AVERE

The European Association
for Electromobility

GTR Issues

Part A Testing

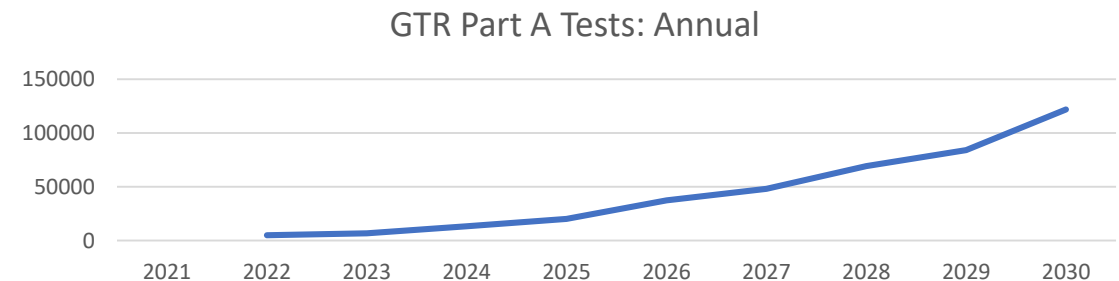
- Full WLTP/ EPA range testing, even with short-cuts, is exhaustive
- No flexibility for CP approved alternate procedures
- Two-year increment on testing should be re-examined
- Testing burden would increase as the number of available EV models increase dependent on clarification of monitor family definition

Part A testing burden example:

500 Models in 2022, 667 in 2023+

Monitor families per model: 2 in 2022, 4 in 2025, 6 in 2030

5 tests per family

Revisit Part A Monitor Family Definition, Test Interval, and CP Flexibility

Part B Battery Durability Families

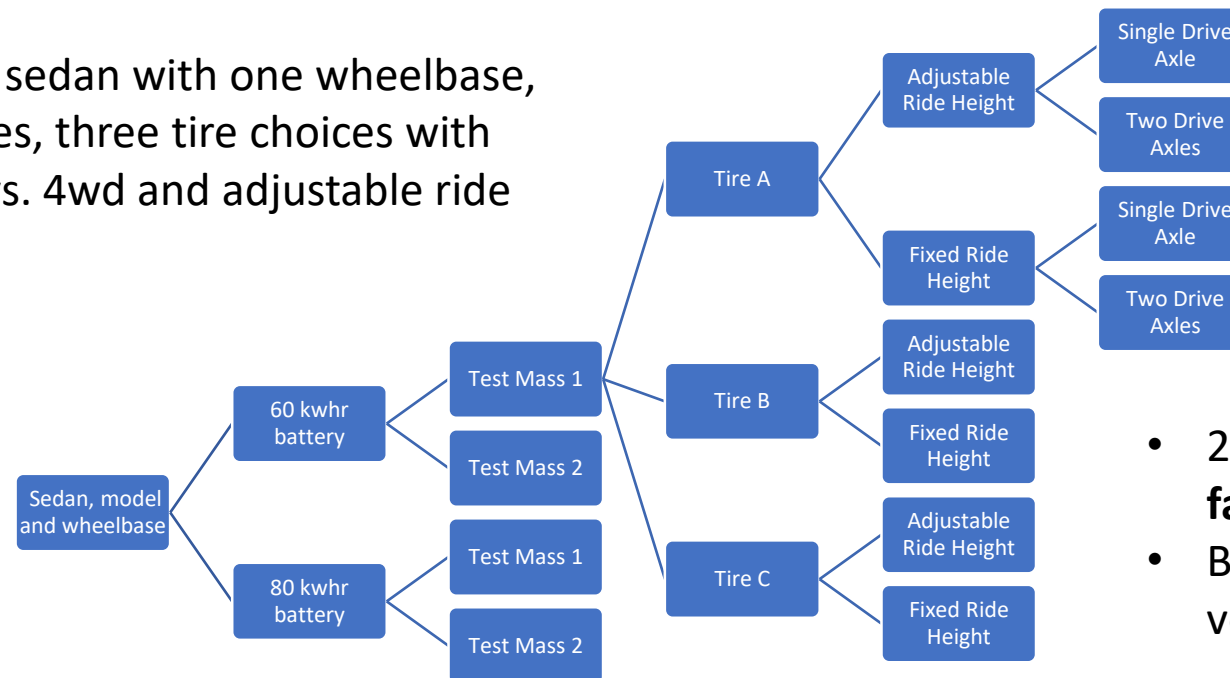
As written, the draft GTR requires a separate battery durability family for any change in energy consumption or certified range. The battery durability families are also a subset of the Part A verification monitors and must be identical in other areas that do not battery durability such as drive axles and n/v ratios. The specificity in defining Part B battery durability families will lead to an overly burdensome increase in electric vehicle requirements.

Example is a sedan with one wheelbase, 2 battery sizes, three tire choices with option of 2 vs. 4wd and adjustable ride height

- $2 \times 2 \times 3 \times 2 \times 2 = 48$ battery durability families for One Sedan Model
- Becomes 96 families if a wagon version is offered

Revisit Part B Monitor Family Definition and Flexibilities
